Case File Number: PLN20124

Location:	1431 Franklin Street
Assessor's Parcel Number(s):	008 062100807
Proposal:	Major Conditional Use Permit and Regular Design Review to construct a 27-story (425-foot tall) 419,480 square feet office tower with a parking garage above grade.
Applicant:	TC II 1431 Franklin, LLC
Contact Person/ Phone Number:	Kyle Winkler, Tidewater Capital/(510) 290-9901
Owner:	TC II 1431 Franklin, LLC
Case File Number:	PLN20124
Planning Permits Required:	Major Conditional Use Permit for large scale development; Regular Design Review
General Plan:	Central Business District
Zoning:	CBD-P Central Business District Pedestrian Retail Commercial Zone Height Area 7, no limit
Environmental Determination:	Determination Pending, Environmental analysis to be conducted prior to any discretionary action
Historic Status:	Project site is located within an existing listed National Register historic resource, the Downtown Historic District Area of Primary Importance (API).

Office Entitlement - Response to Design Review Analysis
11/09/2021

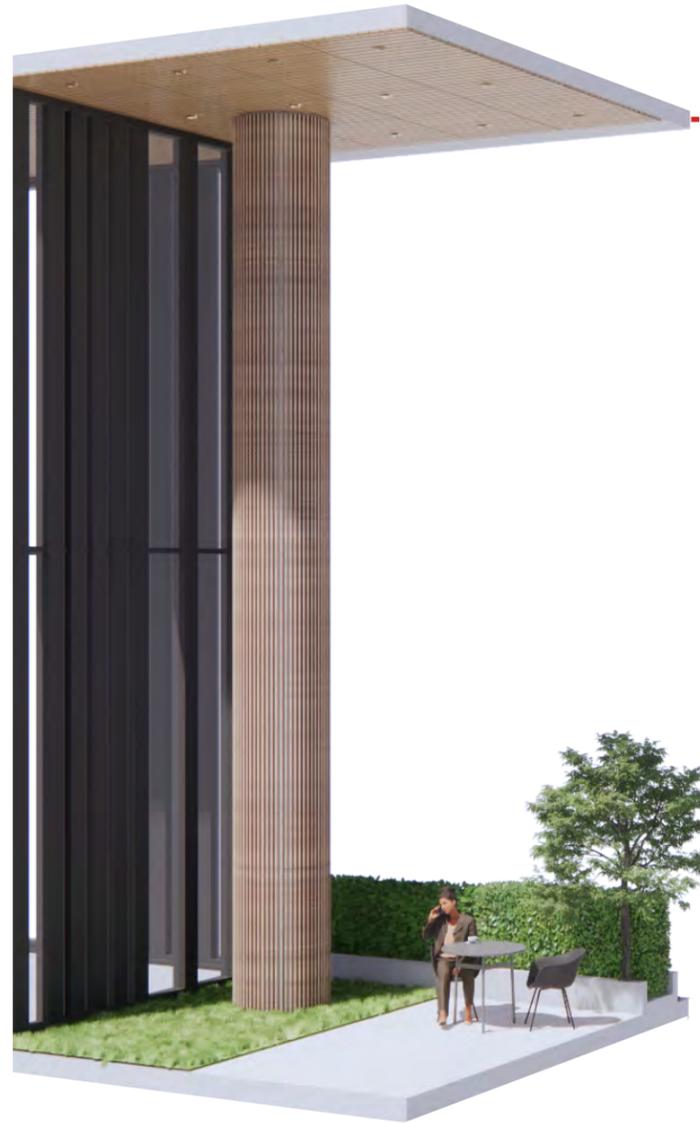
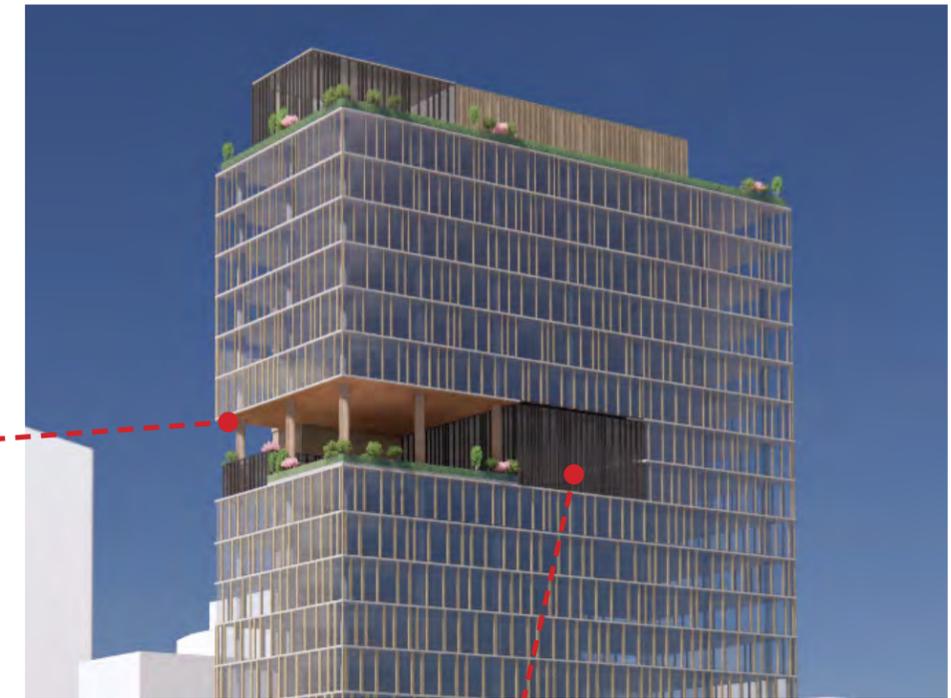
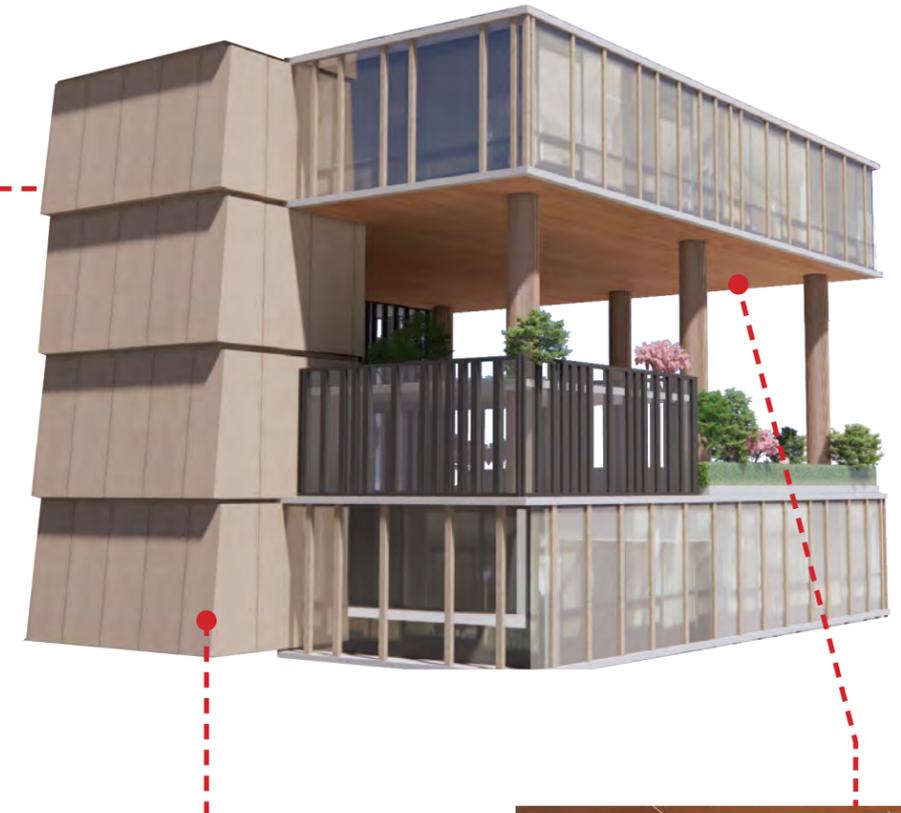
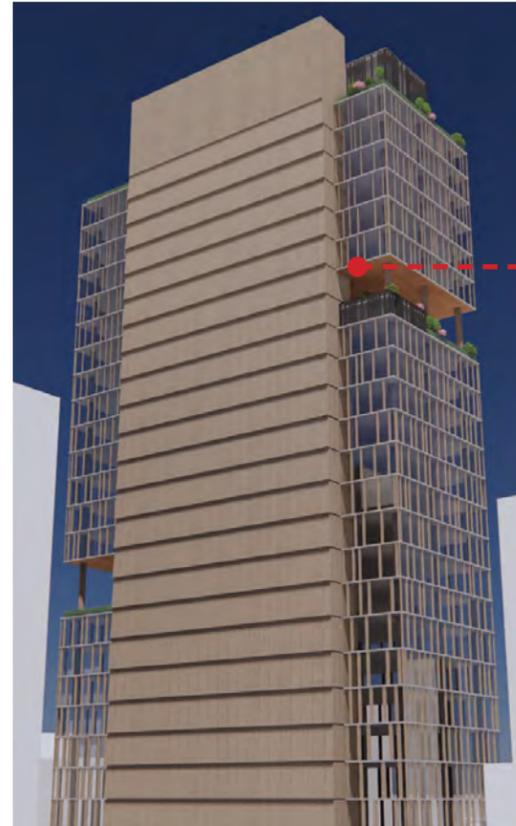
More information is required.

Section 6.3.1 seems to be written with Type III buildings in mind, not Highrise buildings of this size. But saying that, Section 6.3.1 also goes on to say, 'Recommended exterior treatments include decorative brick, wood or high-density wood composite, or cement panel siding that contain horizontal or vertical lines to provide visual interest.' We are proposing to use powder coated metal panels, glass curtain wall, and bricks (at the base). The following details help explain the finishes and details at the upper levels of the building.

Column treatment at lobby and amenity spaces

Slatted wood finish columns

Proposed mural in lobby is visible from street

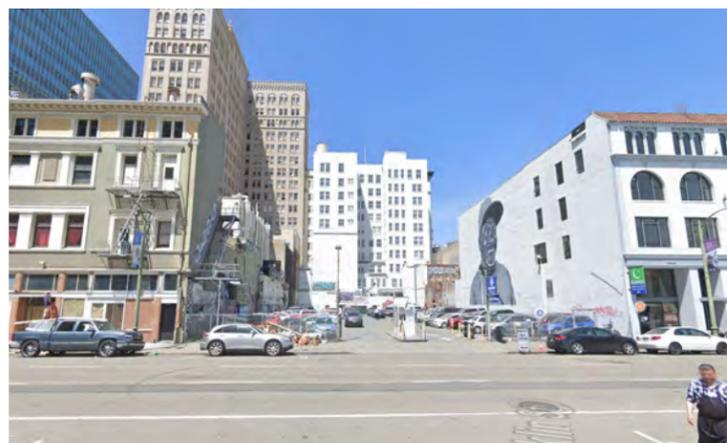
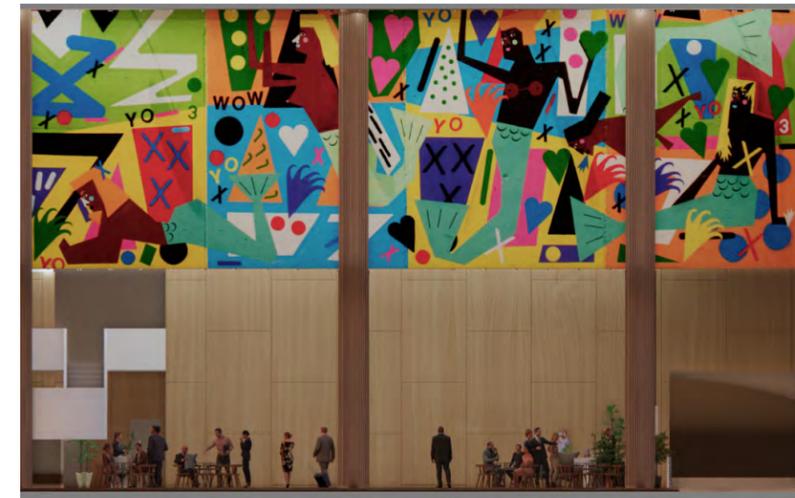
The proposed design does not meet this finding. The proposal does not provide evidence of consideration given to texture, materials, colors, and appurtenances in relation to the surrounding vicinity.

The area immediately adjacent to the proposed project is filled with a large variety of different types of projects. To try and define an appurtenance that would best typify the area is probably not possible. Within a block radius of the proposed site a 400-foot-high tower without windows at the lower 5 floors, a modern tower recently completed with an all-black glass façade, a mid-century modern reflective glass Highrise building, a Greek revivalist building, a gothic revivalist building, Italianate Villa style building, a neo-Moorish style building, a Spanish colonial revivalist style building and pretty much any other imaginable esthetic built between 1850 and today.

The difficulty of creating a new building that has some of the physical appurtenances or characteristics of the district is that the area so diverse and rich in variety. The most important characteristics of this area that should be maintained at all costs is the ability to walk around the streets of the city and feel one can engage with each of the buildings. An empty parking lot, or building with no windows, or even a building with dark reflective glass at the street level are aspects that make a street undesirable to walk down. The historic district of Oakland is filled with street life and cafés that bring life to the experience of walking the streets. The proposed design is open and inviting at the street level. There is art work that is familiar to the streets of the historic district in the form of large scale murals, the materials are similar to the better examples of the historic district, there is a quality to the detailing that will last for many years to come, but most importantly, the front façade is designed with large very transparent vision glass, not, black or reflective glass, and is open for people to see in and feel part of the lobby.

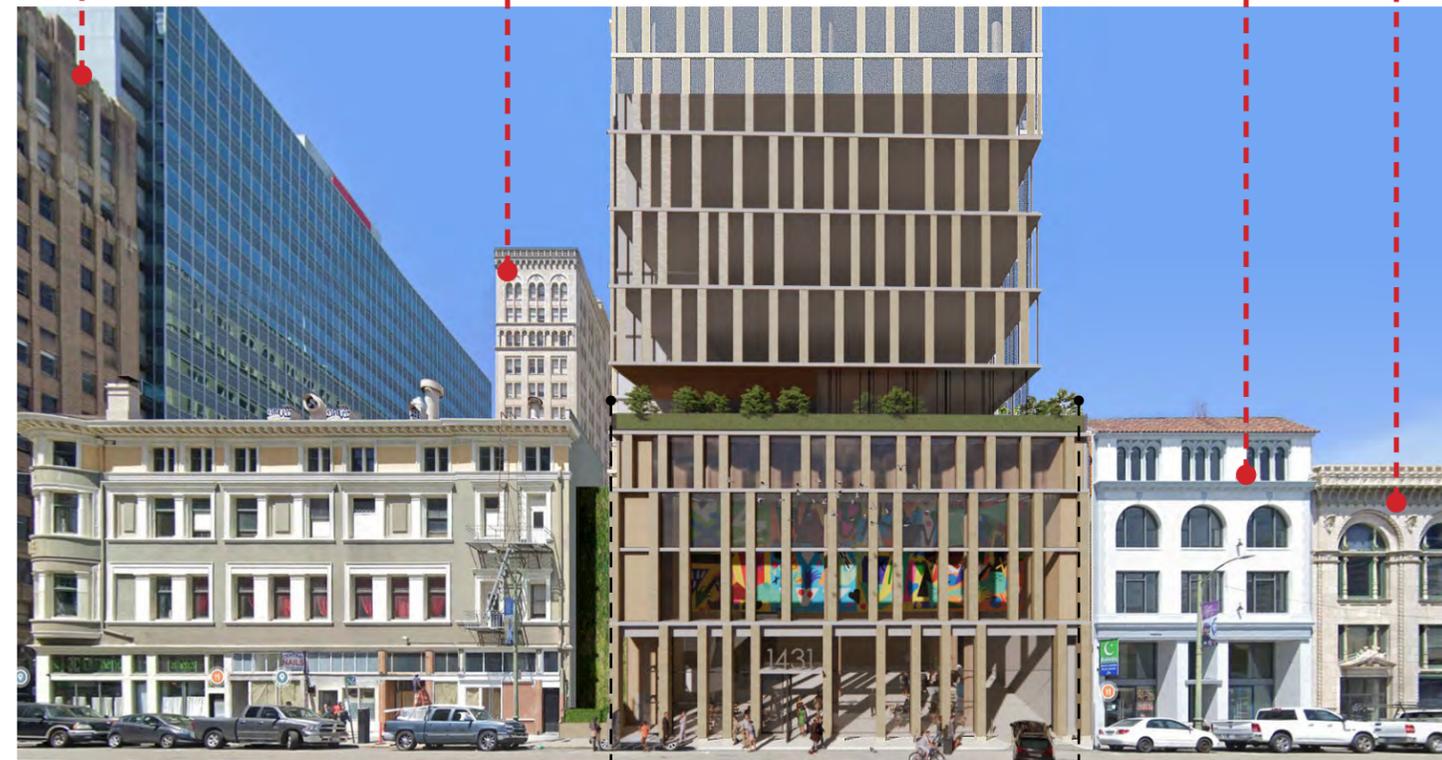
The proposed base of the tower does not conform to the API in rhythm, composition, or patterns of openings. More details must be provided on the ground floor lobby.

The base of the building has been redesigned to better reflect the widths and rhythm of the facades on the street, and entrances that reflect the patterns on the street. As previously noted, the revised design of the proposed building has a strong relationship to the adjacent buildings in terms of massing and, it's modern interpretation to the predominately classical horizontal layer that exists in the Historic district. The pattern of windows also mimics the window layout of the adjacent buildings in a modern way. In addition, the base of the proposed building will have a traditional brick base to pick up on the similar use of materials that are prevalent on the adjacent buildings in the Historic District. In addition, we have located key cornice lines to match the adjacent buildings. But it is worth noting that the cornice lines of the two adjacent buildings are not at the same height or size. With this in mind, we elected to split the difference and make for a compromise geometry that is intended to be visually as cohesive as possible.

Project as it relates to the context as a whole

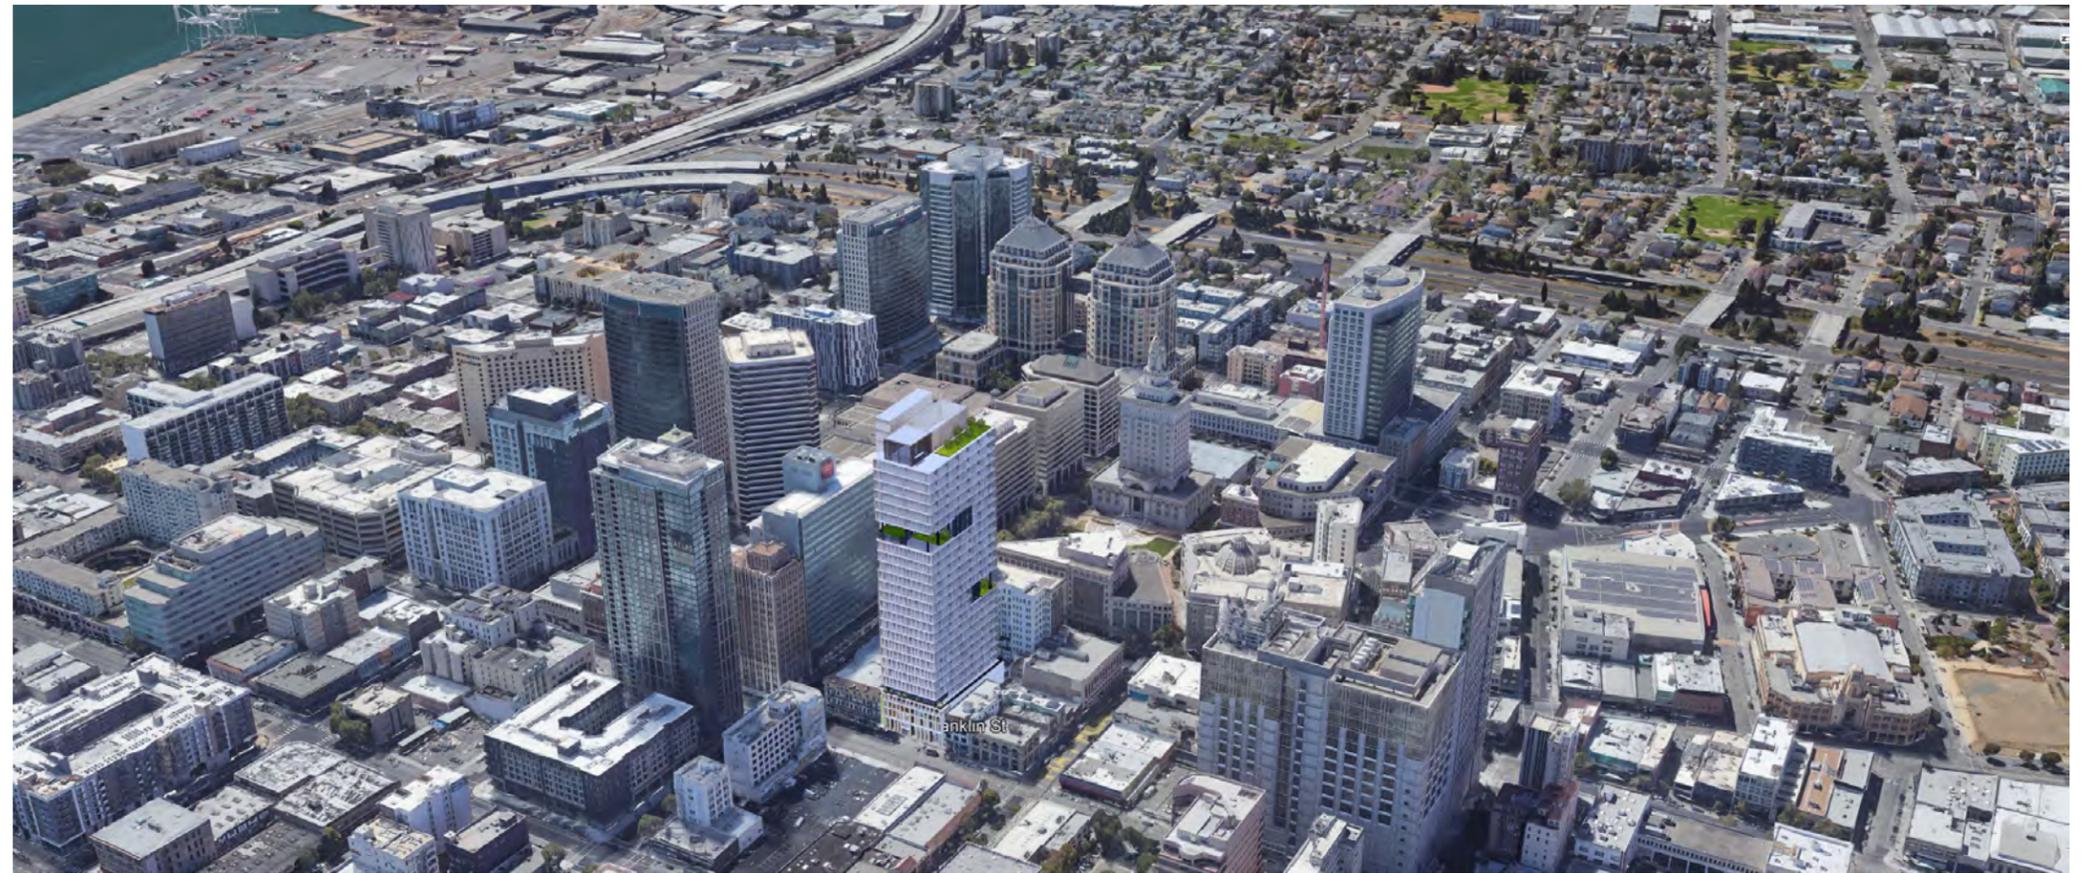
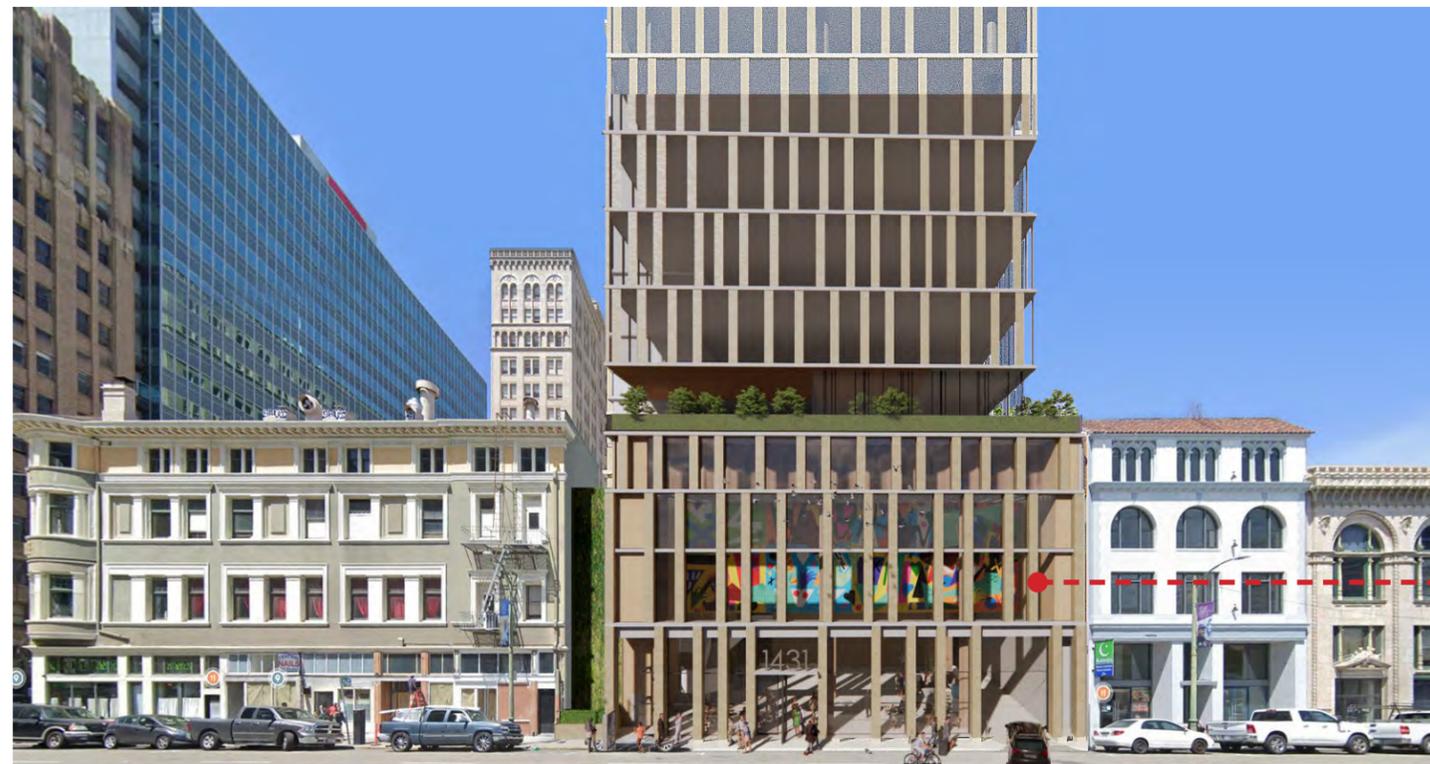
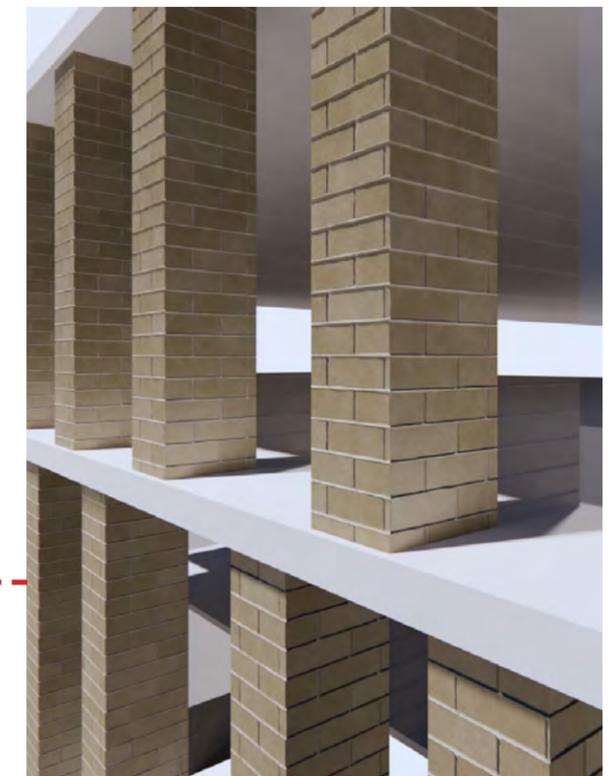
The proposal does not reflect the level and quality of visual interest of the API contributors or otherwise enhance the visual interest of the API. More details of composition, materials and projection are needed

There has been great care taken in the deliberate combination of materials and proportions to create a very modern vernacular the is cohesive and complimentary to the adjacent buildings.
